**From:** Christopher Rollins [mailto:rollinssurvey@gmail.com]  
**Sent:** Tuesday, January 25, 2022 1:57 PM  
**To:** Steve Halleran  
**Subject:** Brite Lite Expansion

Hi Steve,  
I have no objection to the proposed pole barn on the Brite Lite property as long as:

A1.1	<b>BIEBEL BUILDERS, INC.</b> <small>3189 US RT 5 SOUTH, WINDSOR, VT 05089 802-674-9155</small> DESIGN - PLANNING - CONSTRUCTION	PROJECT LOCATION	SCALE	DATE	REVISION DATE
		DRAWING	DATE	APPROVED	
		BRITE LITE ELECTRIC PLAINFIELD NH TRAILER SHED	3/8" DRAWN BY PAUL B	01/17/22 APPROVED

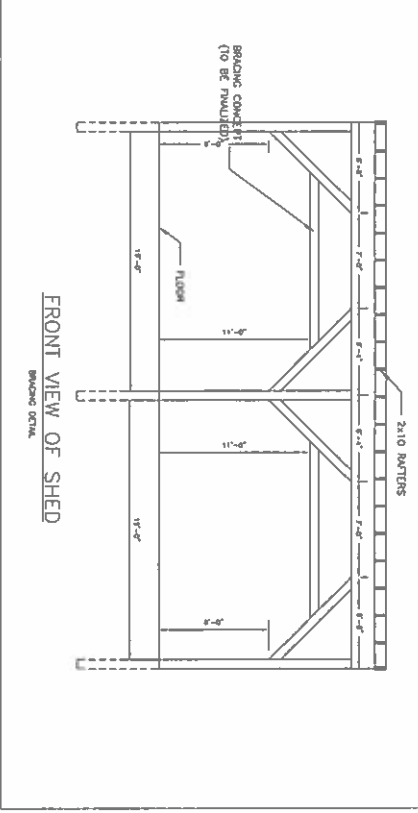
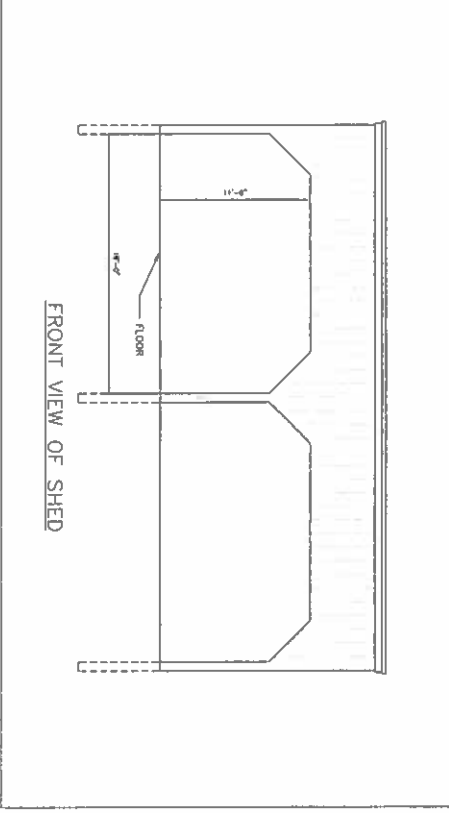
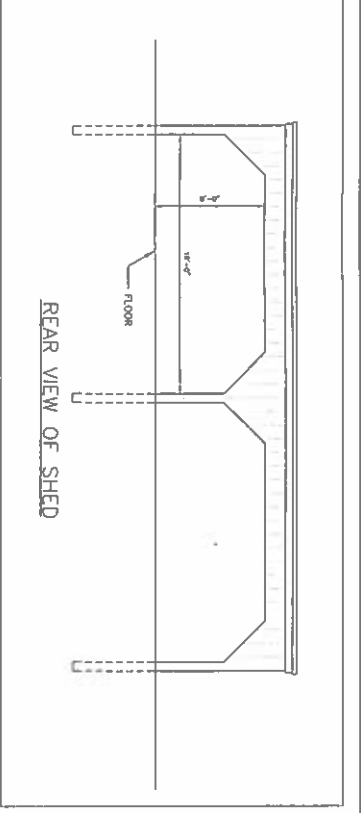
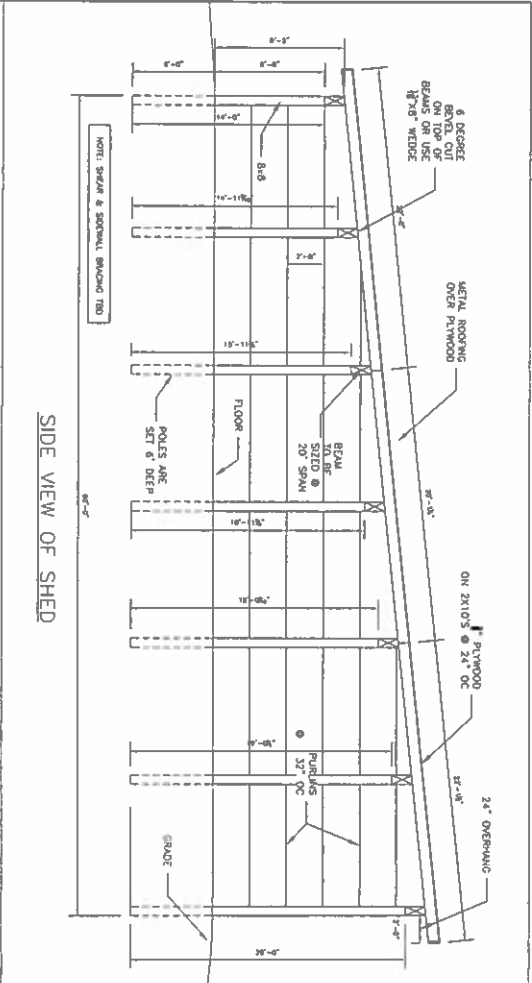
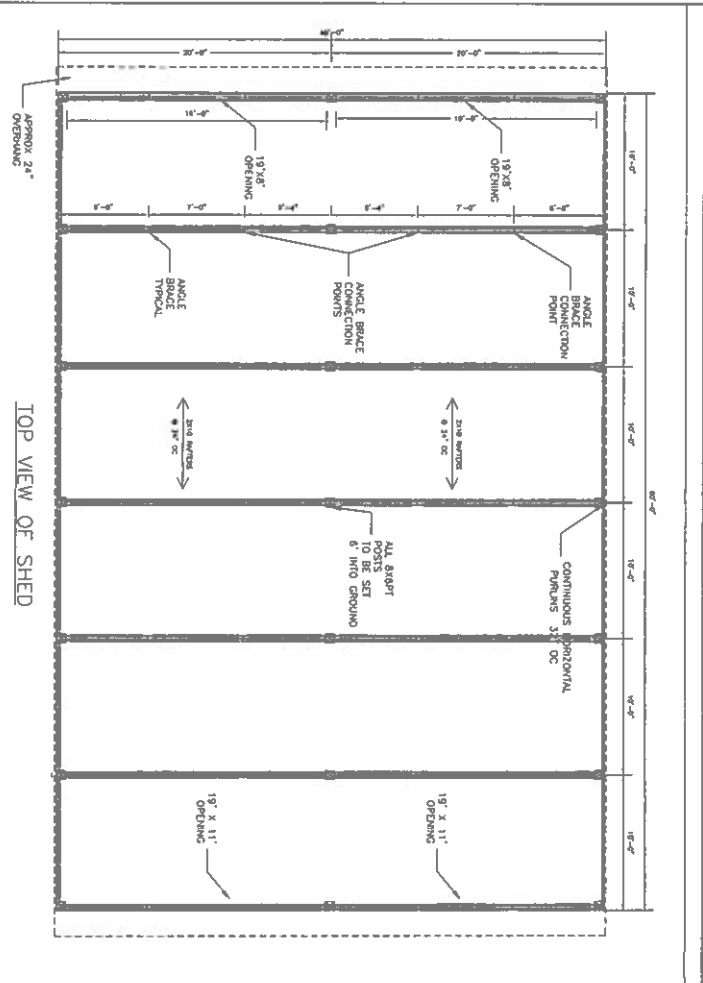
1. Maintain 15'+ from the lot line per zoning.
2. Maintain any applicable wetland buffer.
3. Take precautions to manage runoff caused by the new impervious area, since the runoff is directed to the brook.
4. Observe the required maximum of 40% lot coverage for impervious surfaces. This is important on the subject property because of the brook.
